Town Of Charlton Planning Board

RE: Mancini and VanGuilder (247.-1-34) Proposed 4 lot Sub Division

Public Hearing 7:30 PM

RE: Mancini and VanGuilder (247.-1-34) Proposed 4 Lot Subdivision
REVISED PLNS DATED 8/17/2022
Public Hearing 7:30 p.m.

Freshwater Wetland B-58

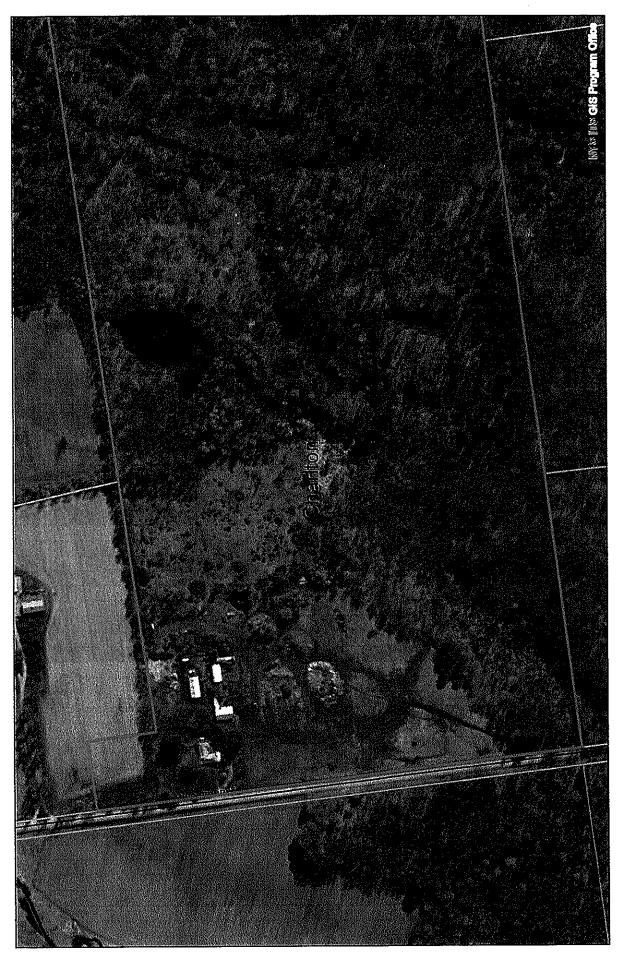
Please see the 2 attached documents. The first shows what is officially mapped and regulated by DEC. As you can see, the map doesn't cover all of the wetlands on site. We are only able to extend official maps for 500 feet, which we did in this case. The second document shows the wetland delineation and sub-division map.

Please remember that just because a wetland isn't jurisdictional to the DEC, doesn't mean it isn't a wetland. The US Army Corps of Engineers may likely have jurisdiction over all wetlands on site and they have no mapping requirements like DEC.
